PARTS & SERVICE NEWS

REF NO.	AA05006
DATE	January 19, 2005

SUBJECT: NEW PAYLOAD METER III™ SCOREBOARD KITS

PURPOSE: To introduce new scoreboard kits to the field.

FIGURE 2. SCOREBOARD (PC1137)

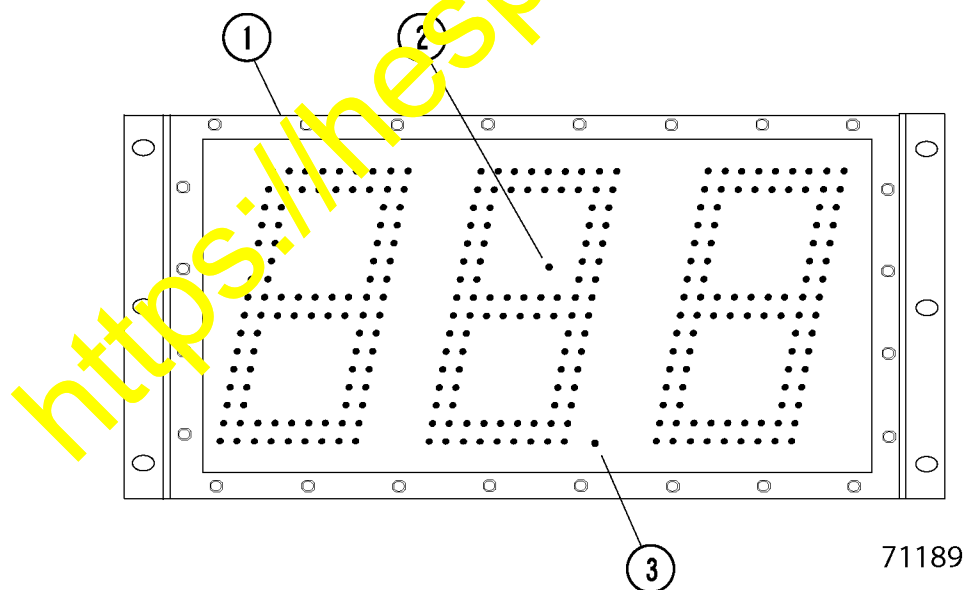
Komatsu is releasing an improved version of the Payload Meter Scoreboards (part number PC1137). The new scoreboards (Figure 1) are ultra-rugged LED electronic display units designed to withstand the vibration, dust, heat, and extreme temperature ranges associated with mining operations. These scoreboard kits will only work with trucks equipped with Payload Meter III systems. Multiple scoreboard kits (Table 1) were created that allows the choice of installing a single scoreboard (driver's side) or dual scoreboards (both sides) for various truck models.

Processor LED (2, Figure 2)

This LED blinks when the power is applied and the processor is running. It blinks approximately once per second under normal conditions. Fast blinking indicates data reception.

Data Receive LED (3, Figure 2)

This LED blinks every time data is received. The LED is electrically connected to the receive pin of the display. It will illuminate only while data is present on the wire.

FIGURE 3. OPTION SWITCHES

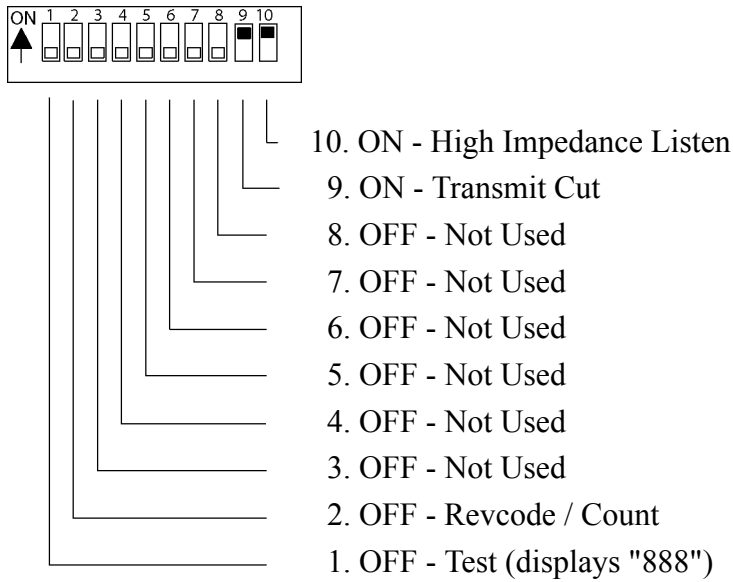
These ten switches (Figure 3) are located inside the scoreboard. The rear cover with the harness connectors must be removed to access the switches. The default switch setting and description of each switch is shown in Figure 3.

SWITCH 1 - TEST (Displays "888")

This switch causes "888" to be shown on the scoreboard for testing purposes.

SWITCH 2 - COUNT

This switch, in conjunction with Switch 1, will cause the scoreboard to count.

SWITCH 9 - TRANSMIT CUT

When this switch is OFF, the transmit feature of the scoreboard is disabled. This is useful if the scoreboard is sharing the RS232 port with another device and the other device is responsible for all communications with the Payroll Meter system.

SWITCH 10 - HIGH IMPEDANCE LISTEN

When this switch is OFF, the remote scoreboard is placed in high impedance mode to share the RS232 connection to the PLM III system.
